UNITED STATES ARMY  
OPERATIONAL EVALUATION GROUP  
LIGHT OBSERVATION HELICOPTER,  
Fort Rucker, Alabama

6  
REPORT OF EVALUATION.

PROJECT NR AVN 2361

1. PURPOSE. To conduct an operational evaluation of Light Observation Helicopter competitive design proposals.

FIG 1 AUTOROTATIONAL CHARACTERISTICS

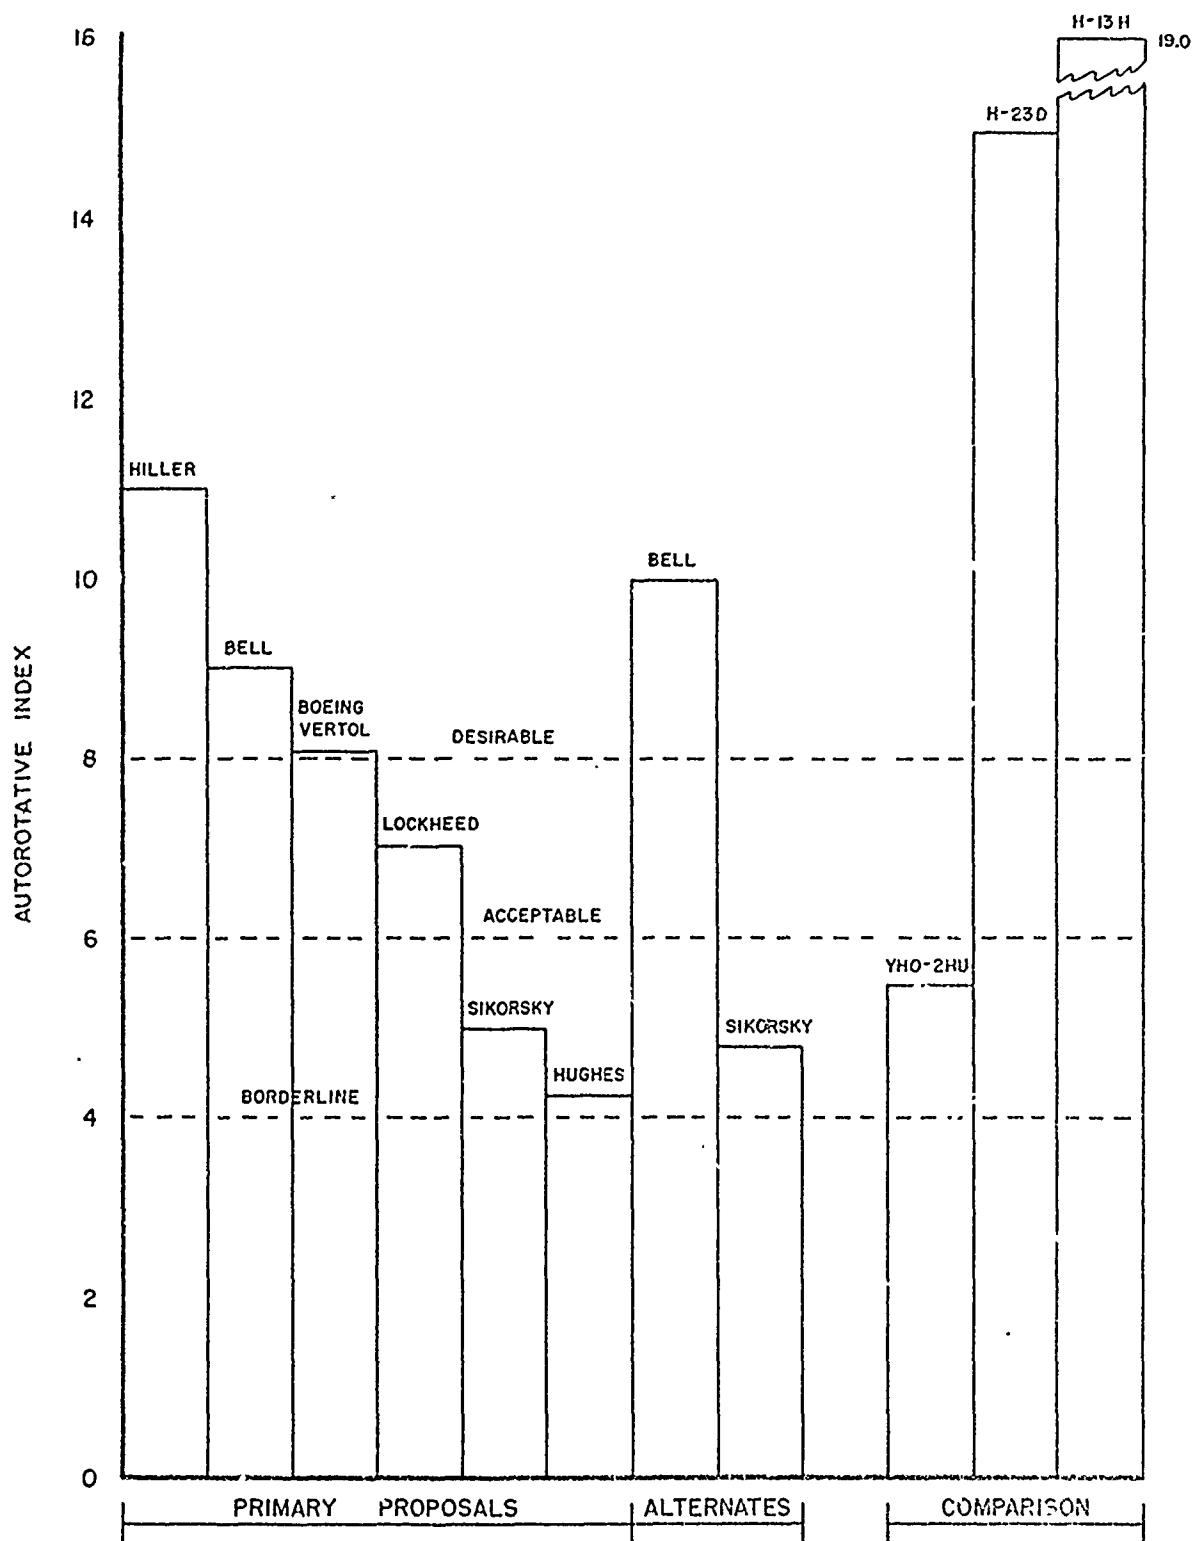
4. The autorotational characteristics, as reflected by the autorotational index (AI), of the top six primary proposals and the top two alternate proposals are shown in Figure 1. As a basis of comparison, the AI of three known helicopters are also shown. Figure 2 is a chart of the factors used and each value. By this method of evaluation and comparison, all proposals are acceptable with the possible exception of Hughes which would be considered a borderline case.

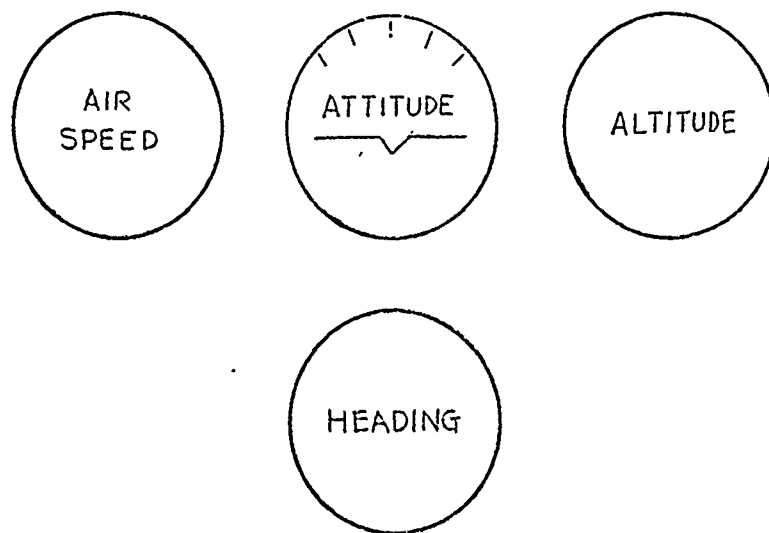
(Provisions of an annunciator panel will be an added cost as compared to caution lights placed at random in the cockpit. Random placement of caution lights is not recommended. The HU-1( ) and AO-1( ) use annunciator panels.)

Figure 3

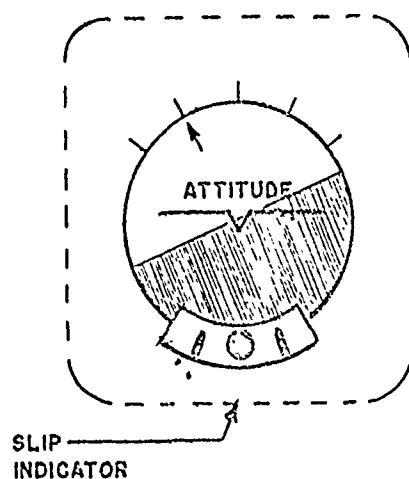
(6) The airspeed, altitude, attitude, and heading indicators shall be mounted in the instrument panel in the approved Army "T" arrangement as illustrated in Figure 3. The altimeter and the attitude, heading, and airspeed indicators shall be of standard three-inch size.

Figure 4

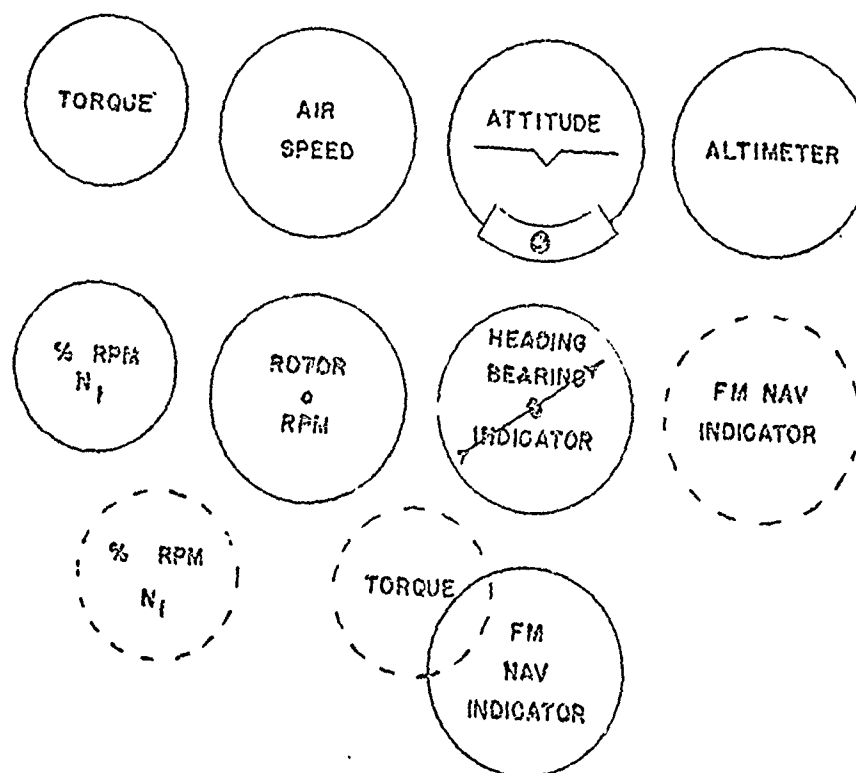
→ See Figure 4. (NOTE: Delete turn-and-bank indicator from paragraph 3.14.1.)

Figure 5

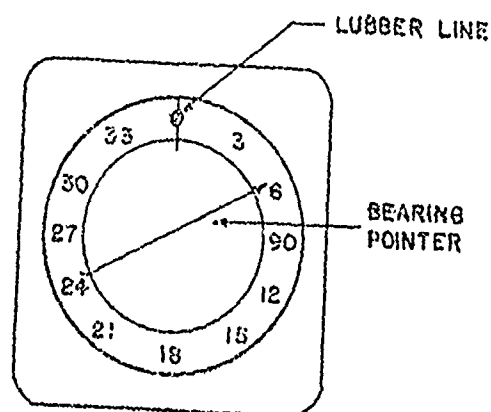
(8) A deviation indicator shall be provided, suitable for display of navigation information from the AN/ARC-54 FM Radio Set Homing System. This instrument shall be located as indicated in Figure 5.

(9) Engine instrument arrangement shall be in general accordance with Figure 5. Locations of engine instruments not shown in Figure 5 shall be subject to approval by the Mock-up Board.

FIG 8 (NO COMPONENTS REMOVED)

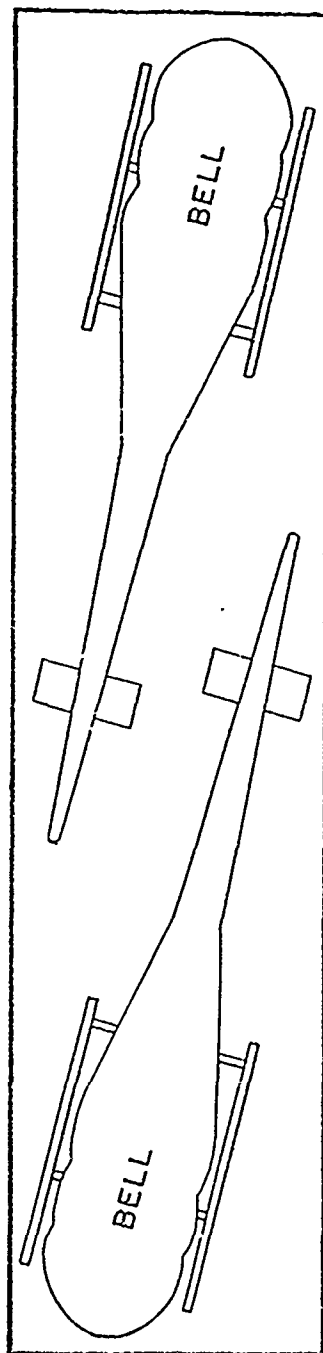
4. <u>Air Transportability</u>					
Nr that can be transported in C-130 without major disassembly (see Figures 7 thru 11)	3 (Note 4)	0 (Note 5)	2	3	5. Must remove main rotor & mast. Does not meet MC. It is questionable that re-assembly can be accomplished in 1 hour for Phase II reqmt. Will meet Phase III reqmt.
